ARCHITECTURAL REVIEW COMMISSION MEETING AGENDA

Department of Community and Economic Development
Meeting Date: April 23, 2020

ARCHITECTURAL REVIEW COMMISSION STAFF REPORT

New Monument Sign: 6942 S. Boulder Dr. (Boulder Hollow Apartments - approx. 1600 E. Fort Union Blvd.)

Proposed Sign

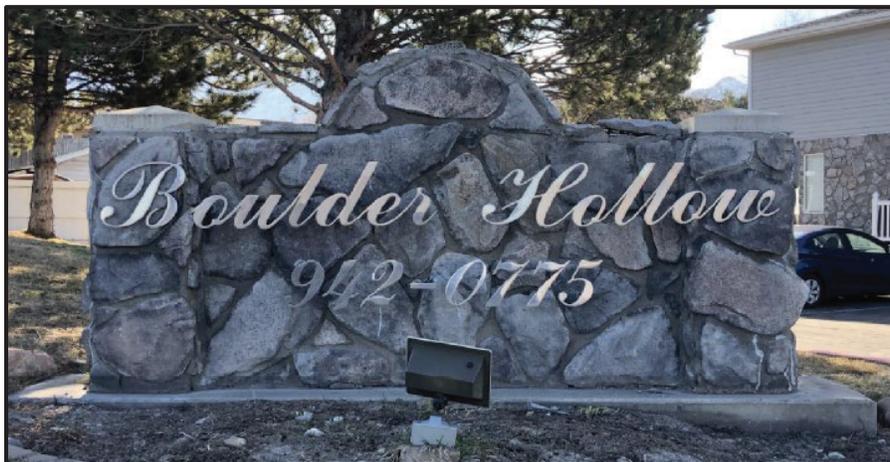
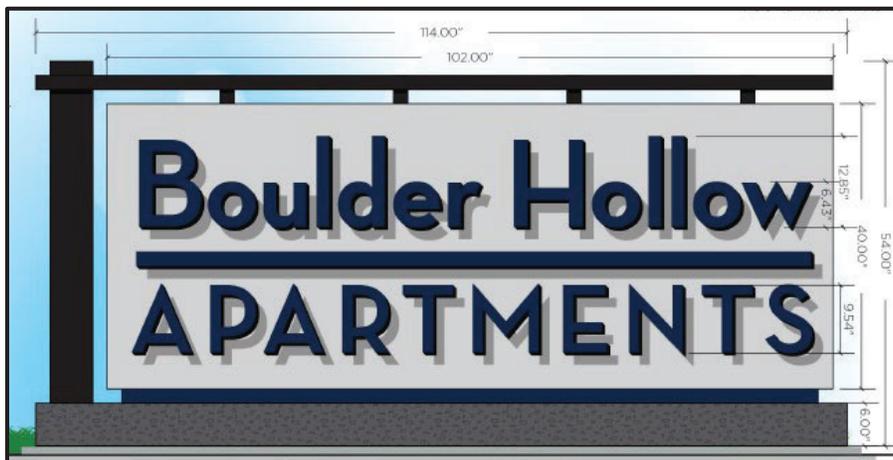
Monument signs are not permitted in the RM (Residential Multi-Family) zone. “Removal of a nonconforming sign or replacement of a nonconforming sign with a conforming sign is required when a nonconforming sign, or a substantial part of a nonconforming sign, is voluntarily taken down, altered, or removed. As used in this subsection, “substantial” means 50% or more of the entire sign structure.” (19.82.130 – Nonconforming Signs).

The applicant is proposing to “remove existing sign elements, no more than 50% of existing structure. Remove lettering, stone veneer, leaving framed wood support walls, center pole, concrete slab foundation. Proposed monument sign refresh not increasing size in height, width or depth, not moving location. To attach to existing pole and footing.” The materials proposed are aluminum frame structure, .090 aluminum skin, drivet stucco finish for base, and aluminum reverse channel letters: halo illuminated white.

Side by Side Comparison

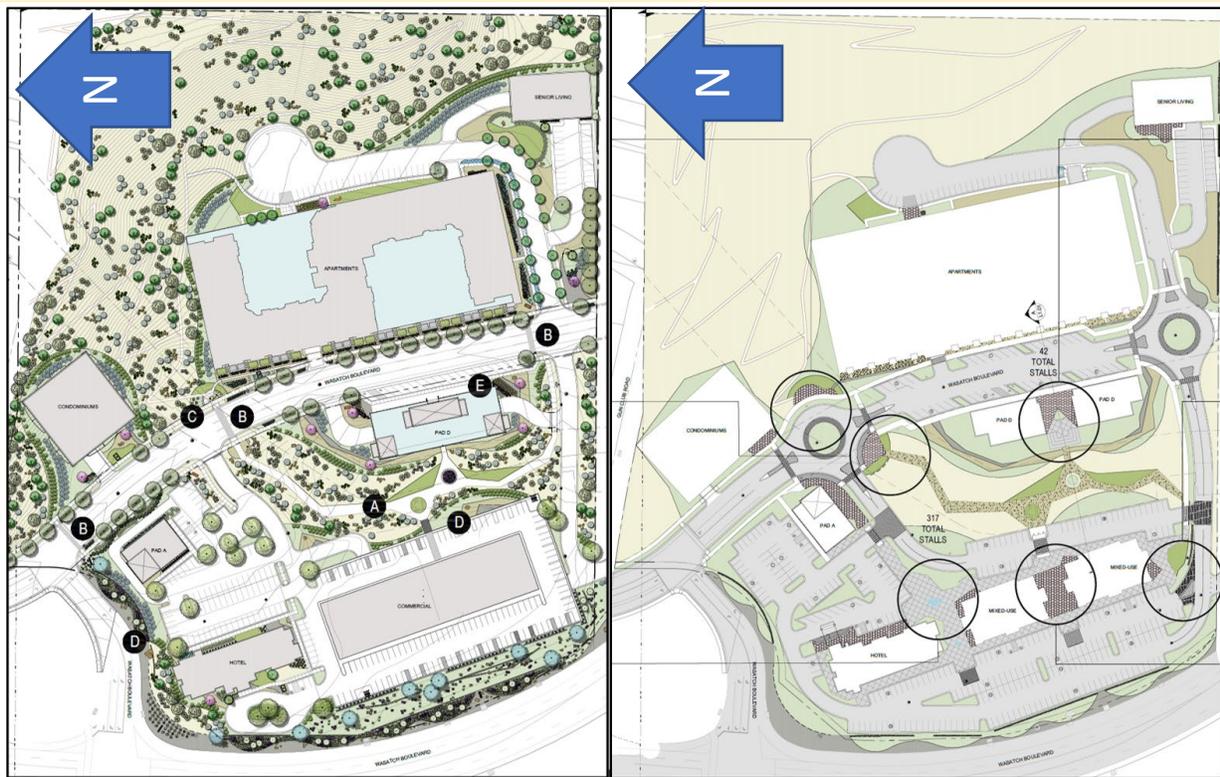
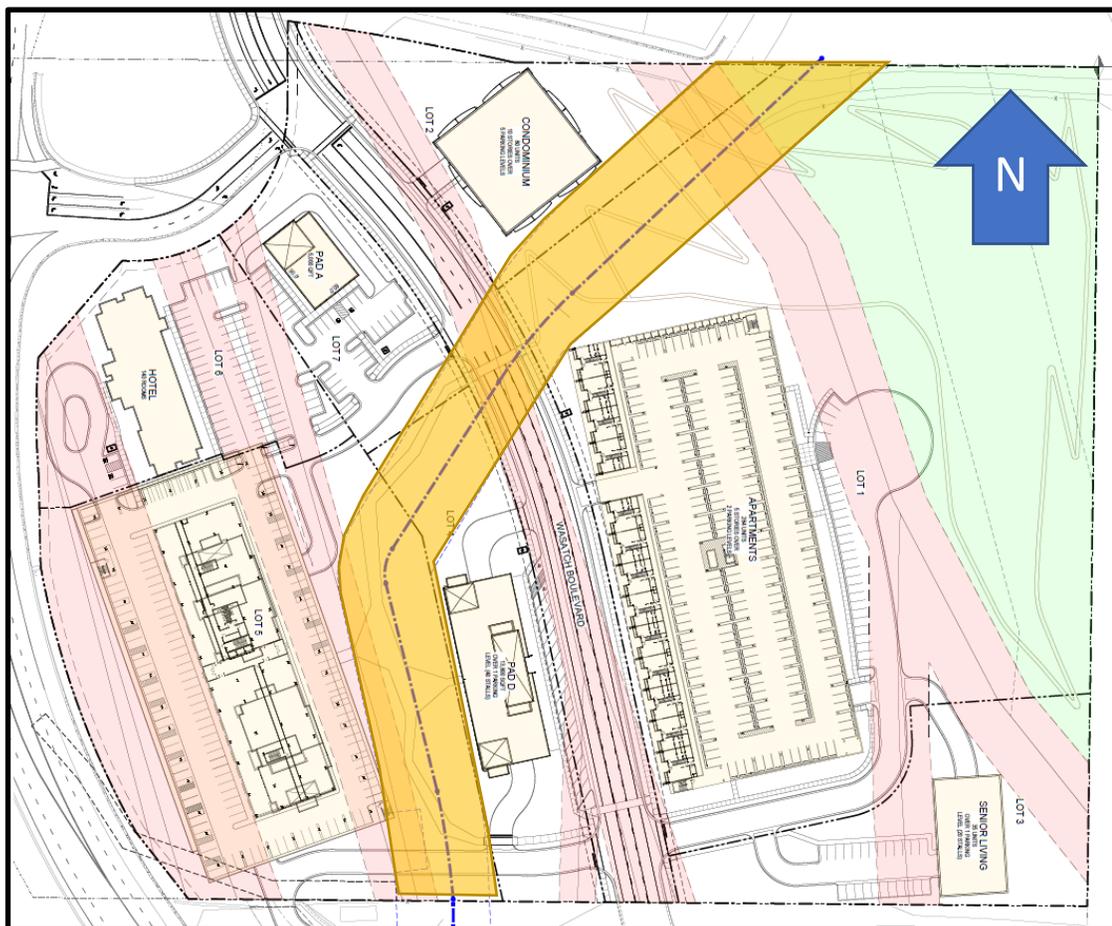
Since the last ARC meeting, the applicant has proposed changes based upon staff and ARC feedback.

- The condominium site and building design has been modified.
- Wasatch Blvd has been redesigned for a slower design speed, traffic circles and additional angled parking.

p. 156 – Preferred Scenario (graphic)

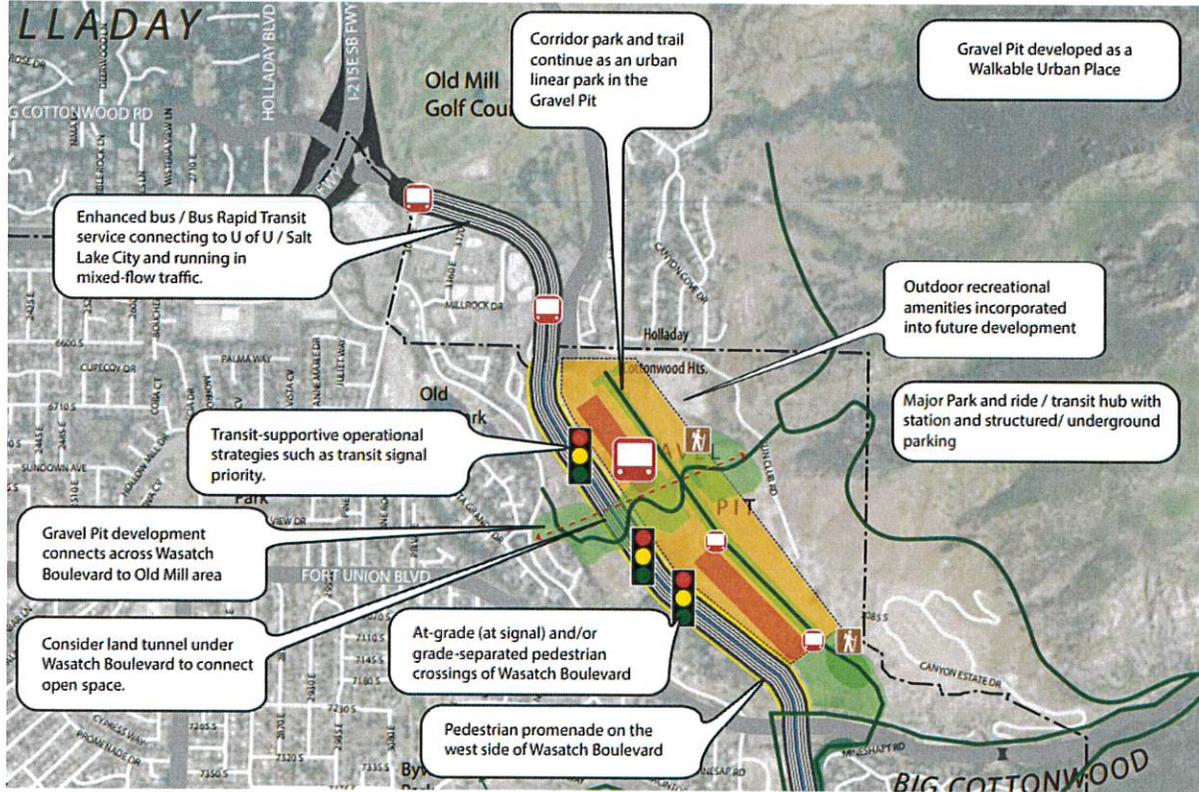
Policy	Notes
Corridor park and trail as an urban linear park in the Gravel Pit.	Substantial compliance. Future development south of this site should tie-in to planned green space.
Gravel Pit developed as a Walkable Urban Place	Site layout is auto-centric with parking lots dividing up buildings and creating a campus layout rather than an walkable urban layout.
Enhanced bus / Bus Rapid Transit service connecting to U of U / Salt Lake City and running in mixed traffic flow.	Not applicable to this project.
Transit-supportive strategies such as transit signal priority.	Not applicable to this project.
Gravel Pit developed connects across Wasatch Boulevard to Old Mill area.	Not applicable to this project. It seems to make more sense to pursue this

Adding a transit-prioritized lane in each direction on Wasatch Boulevard in Segment 1, increasing the corridor's capacity to move people more reliably.	Will the project provide sufficient right-of-way dedication to UDOT to ensure that this policy objective may be completed in the future?
Adding a lane or shoulder for peak traffic use in each direction on Wasatch Boulevard in Segment 3, increasing the corridor's capacity to move people more reliably.	
Initiating an enhanced bus or bus rapid transit line north along the Valley's east side and terminating at or near the Gravel Pit, providing a high-capacity transit possibility to carry people from the Gravel Pit to major activity centers, reflecting a strong travel market. Cottonwood Heights will work closely with UTA to achieve this increased service and infrastructure.	Project will support demand for BRT/high-capacity transit. But over-parked site may undermine this goal.

Encouraging the creation of a major recreational amenity and/or mountain recreation park in the Gravel Pit development creates a recreational focus and hub.	
Completing the Bonneville Shoreline Trail and associated new access points, tying Cottonwood Heights into a regional recreation network.	
Implementing the city's Bicycle and Trails Master Plan by enhancing the on-street bike lane and lowering of vehicle speeds to improve conditions for road cyclists.	Provides an alternative path for cyclists, but SR-190 is not proposed to be improved per this plan and therefore will not facilitate this goal.

Proposed Building Elevations (significant changes highlighted)

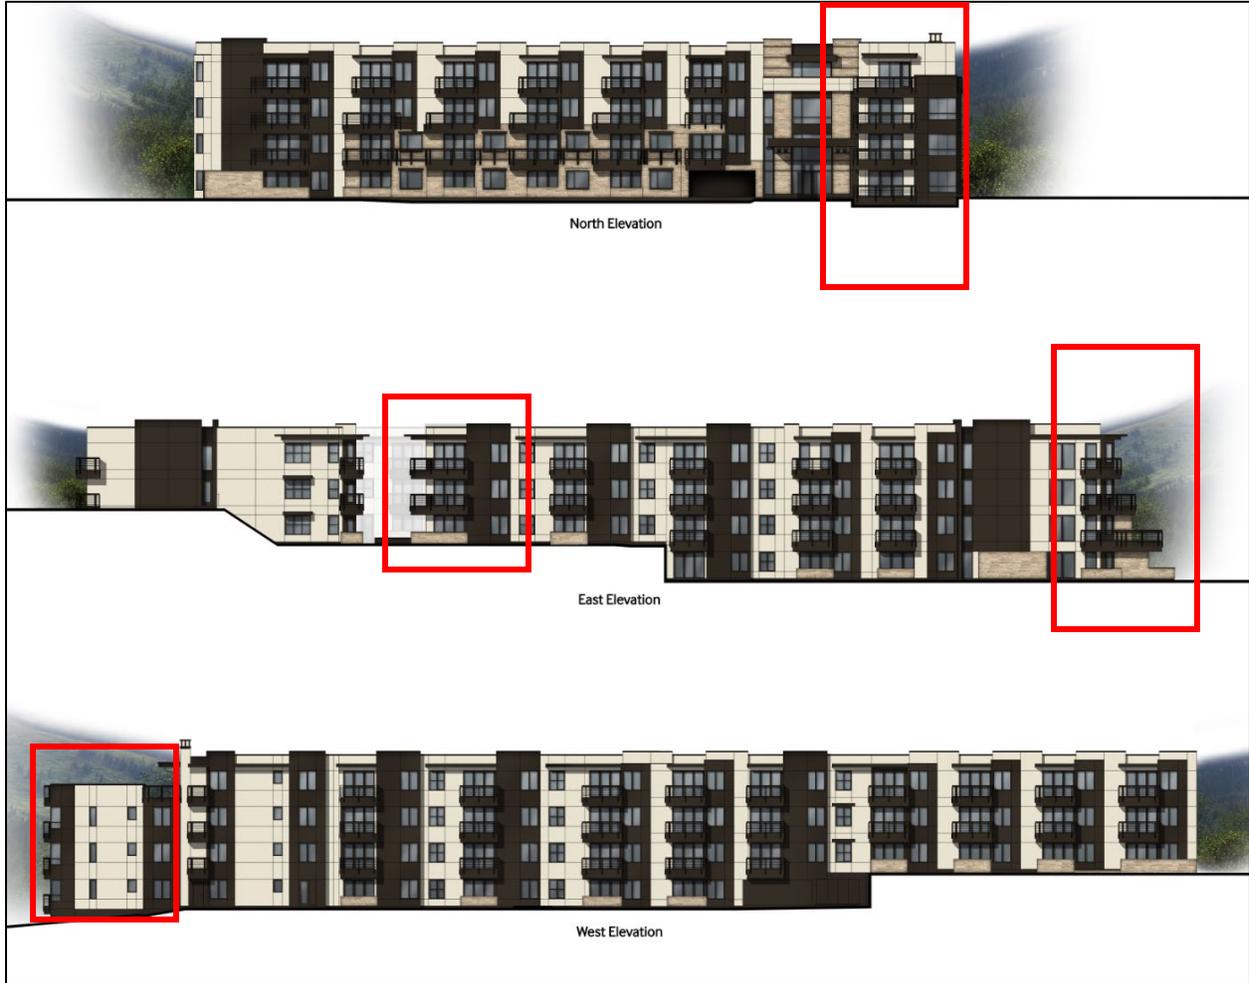
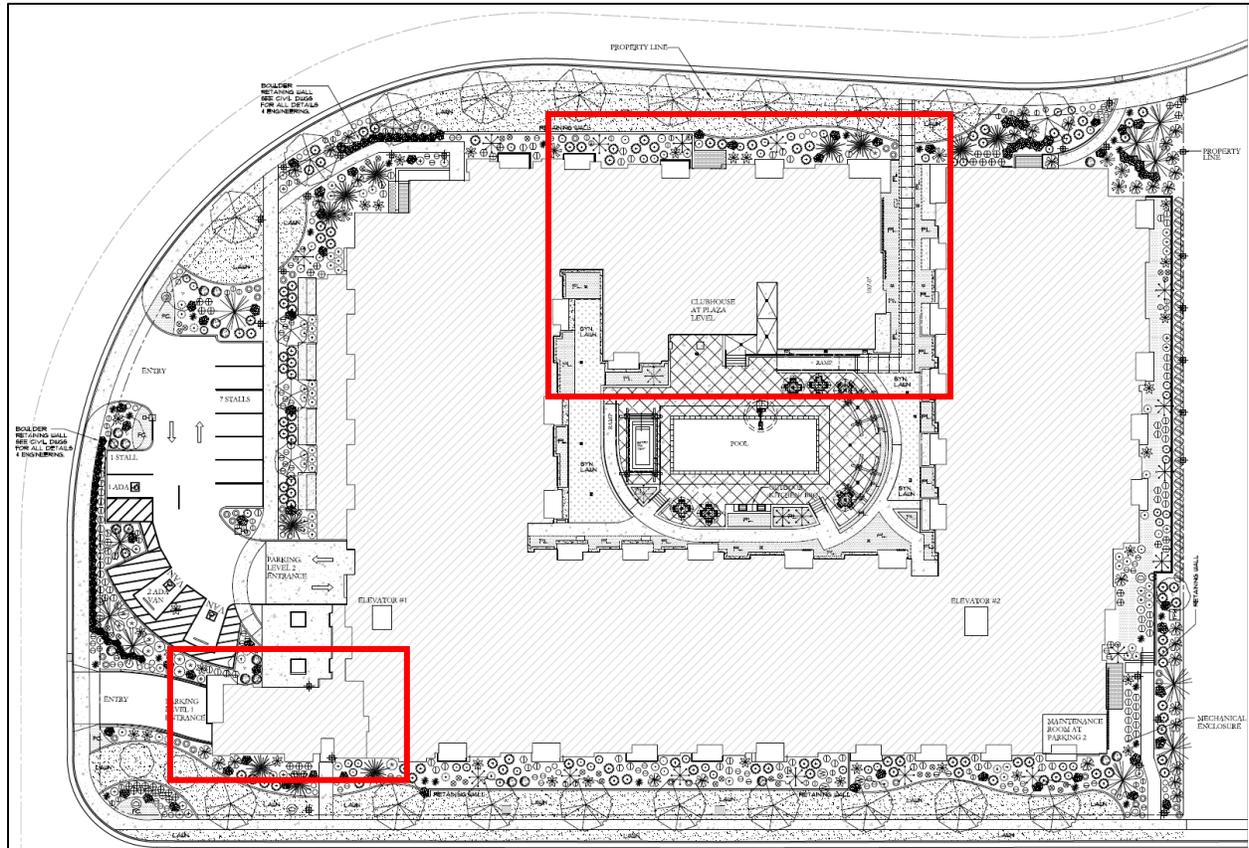
However, the increase in proposed units also results in additional building massing. This change affects the approved site plan by modifying the existing building footprint and reducing the size of the landscape courtyard. The same general architectural materials and style from the previous approval are proposed, and there is no proposed increase in building height.

- The building expansion on the northwest corner of the building has been modified and extended to accommodate more internal units. This revision appears to have an effect on the 'entryway' to the project. Previously, this corner was a clearly identifiable entry feature. The current proposal reduces the identifiable entry features in lieu of more living units. Staff recommends specific care is taken to highlight the northwest corner of the building as an entry feature, and retain those entryway characteristics as much as possible. (Ref. Design Guidelines p. 1, #1)
